Re: 164-170 Croatia Avenue, Edmondson Park – Integrated Development Application: Notice to Supply Further Information

IDA Application No: DA-33/2021, CNR-17700, A-20672

Figure 1: Proposed realignment of Maxwells Creek

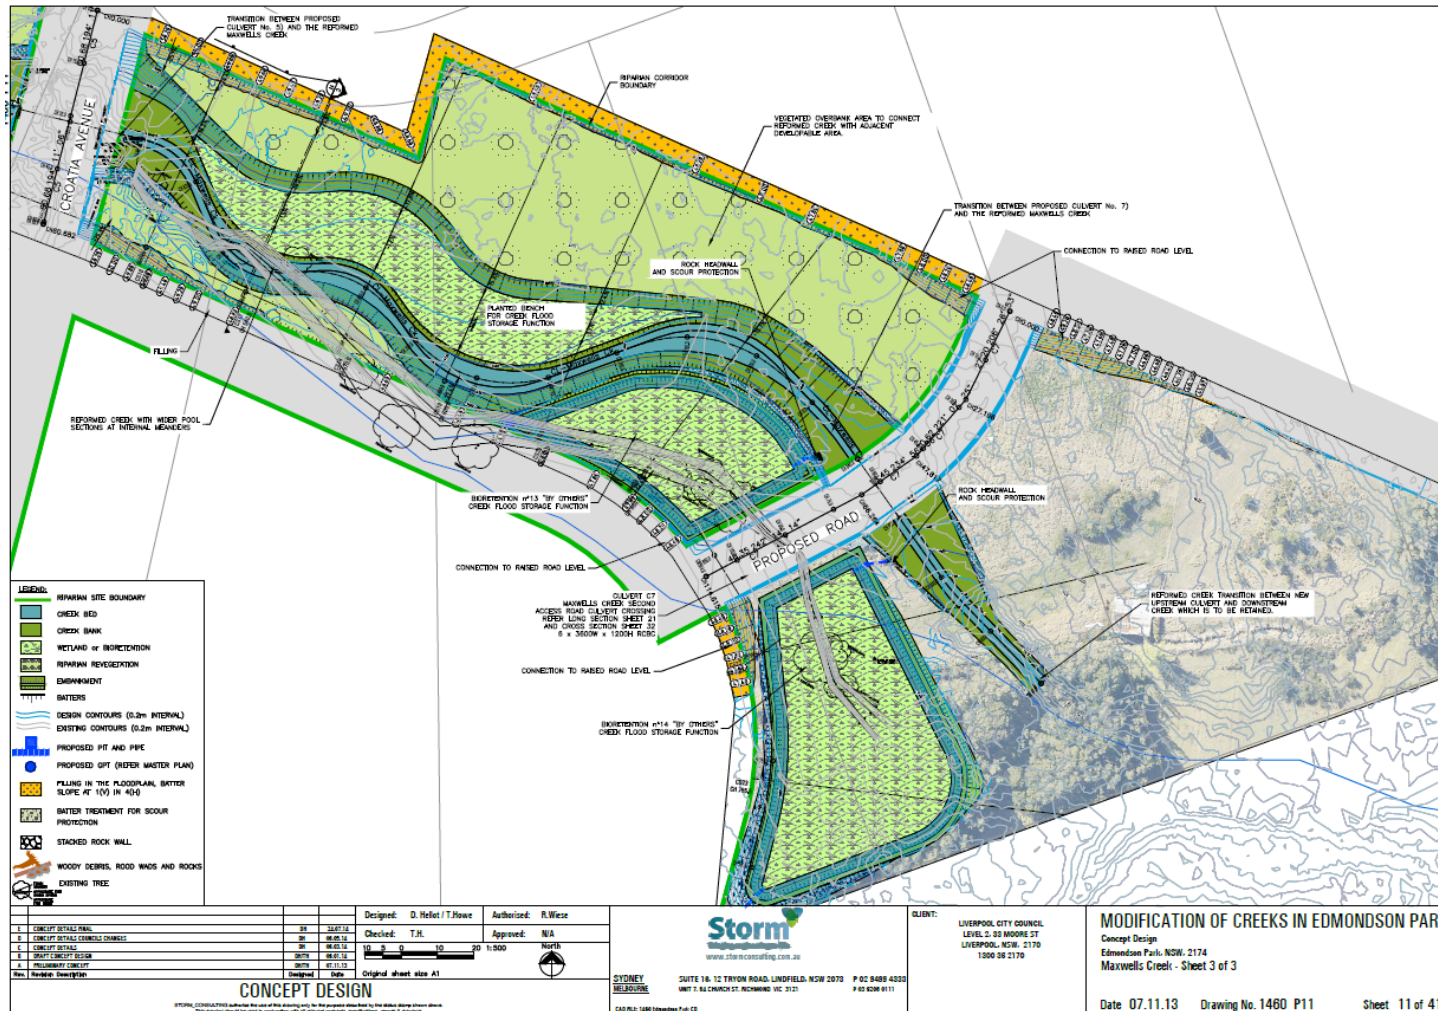
1. Management of RE1 zoned lands

Works within the RE1 zoned lands include vegetation management, realignment of Maxwells Creek (Figure 1), and construction of a new road. These are all included with the current concept development application.

The realignment includes excavation of a new creek bed alignment to the north of the existing creek line, along with battering of the ground on both sides of the new alignment and creation of a flood storage area. This area would be planted. A rock headwall and scour protection would also be installed. The new alignment would pass under a proposed new road and then transition into the existing downstream creek alignment. The new road is not part the current proposal and will be subject to a separate approval process (by others).

The realignment of Maxwells Creek would significantly impact on site CA-AS-01 (AHIMS #45-5-5587). The site comprises five small silcrete artefacts, including two flaked items, a broken backed flake, a small core, and a piece of heat shattered silcrete with a remnant flaked surface. Overall, these items are considered to be of limited archaeological significance, due to the nature of the items which are common item types for the Cumberland Plain, as well as being located within a disturbed context. The location in which they were identified is considered unlikely to retain significant archaeological deposits due to the level of disturbance present.

Retention of the deposit associated with CA-AS-01 in order to avoid further impact to Aboriginal archaeological deposits is considered unwarranted. The ACHAR has been updated to explore potential options for avoidance or retention.

It is understood that exploring all options for avoidance or retention of the site is appropriate at Concept stage, prior to the issue of any DA for physical site works, and that requirements for the management of the sites within the study area would be included as parts of the GTA for the project.
